TREE RETENTION PLAN

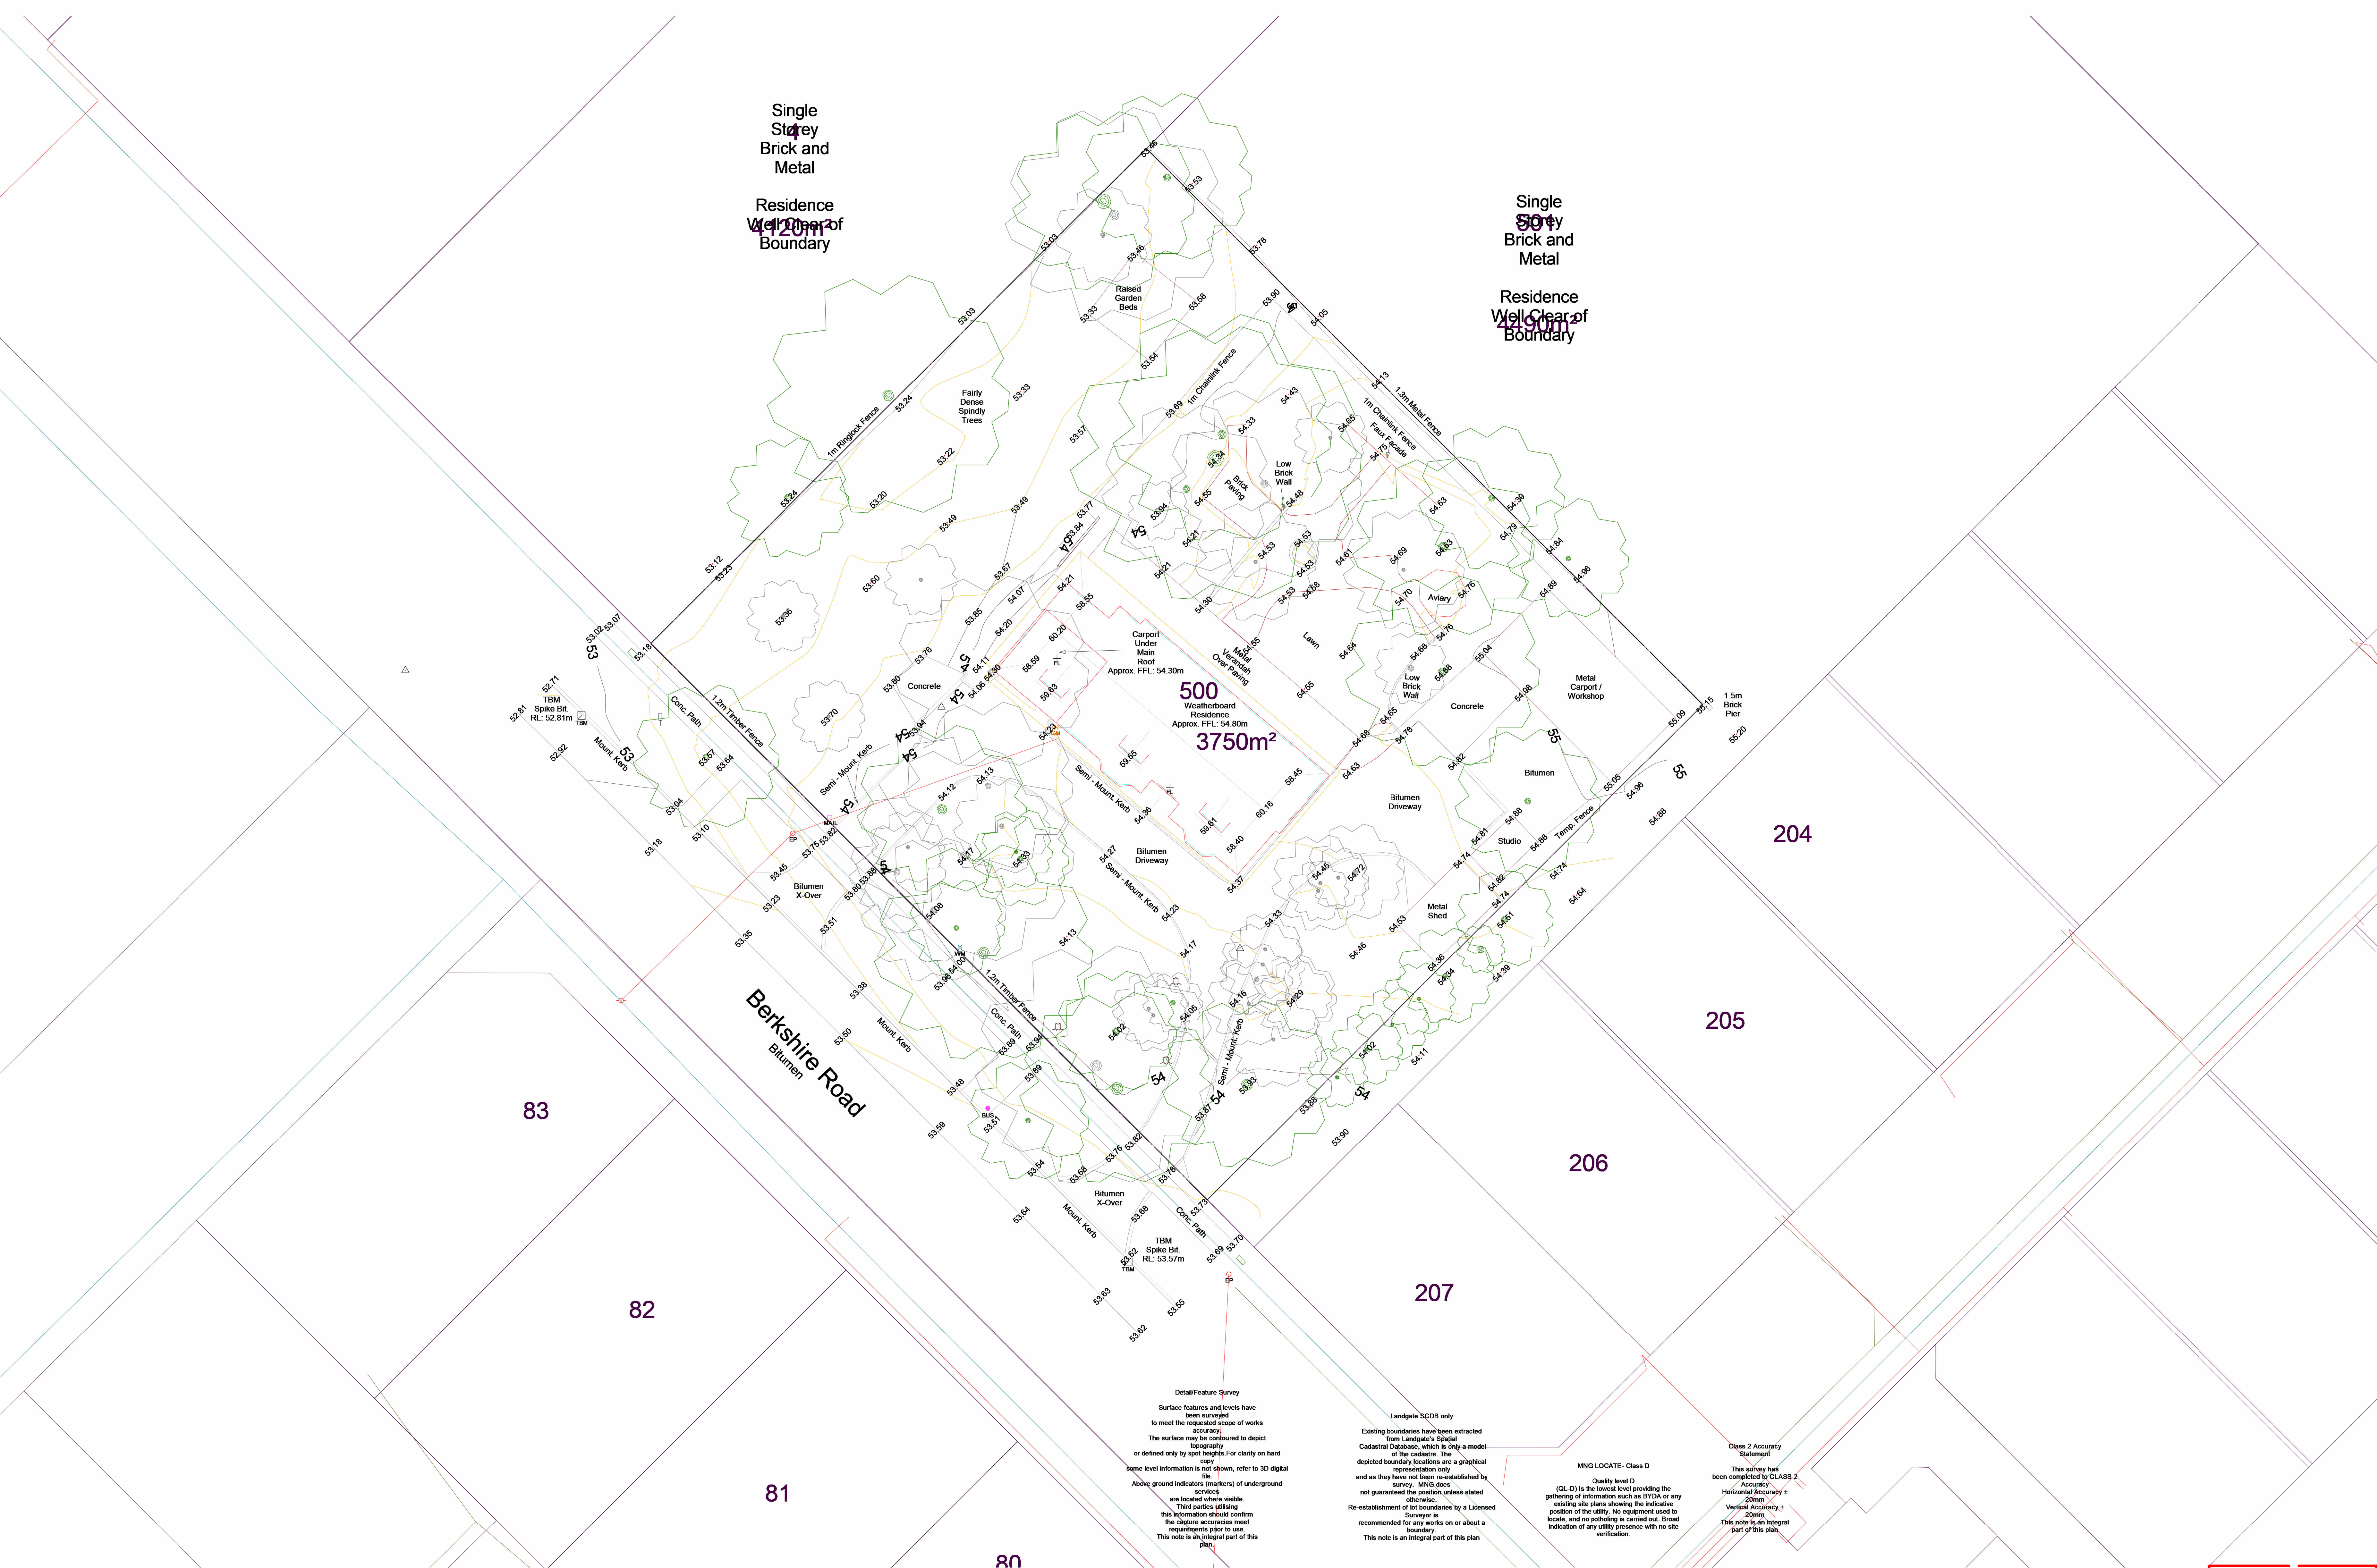
#25 CAN'T LOCATE ON SURVEY. POSSIBLE THAT SURVEY DIDN'T PICK UP DEAD TREE

#21 SUGGESTED TO RETAIN HOWEVER UNSURE OF LOCATION. SURVEY AND ARBORIST REPORT DON'T MATCH UP

UNIDENTIFIED TREES

UNIDENTIFIED TREE
